R02GC

August 16, 2002

RECALL R02GC 'RANGE INHIBITED' LIGHT ACTIVATION INSTRUCTIONS

Figure 2

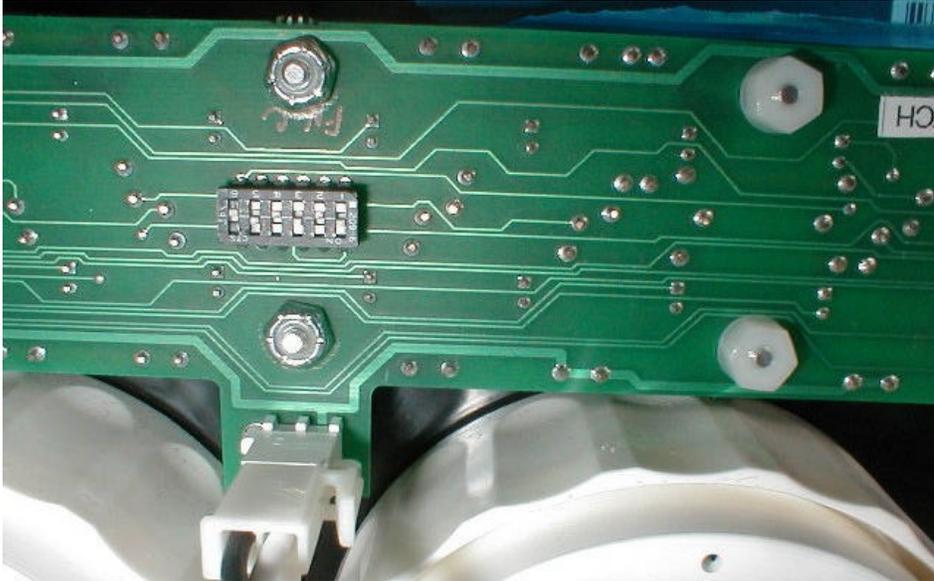
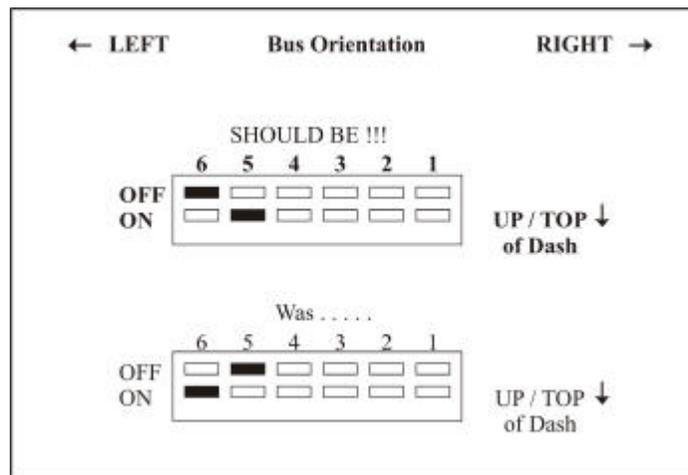
6. When sitting in the driver's seat and leaning over the dash panel, the dipswitch position 6 will be on your left and the dipswitch position 1 will be on your right. See Figure 2 below.

7. Flip switch 6 to "off" position. Down towards bottom of dash panel. Flip switch 5 to "on" position. Up towards top of dash panel. See Figure 3 below.
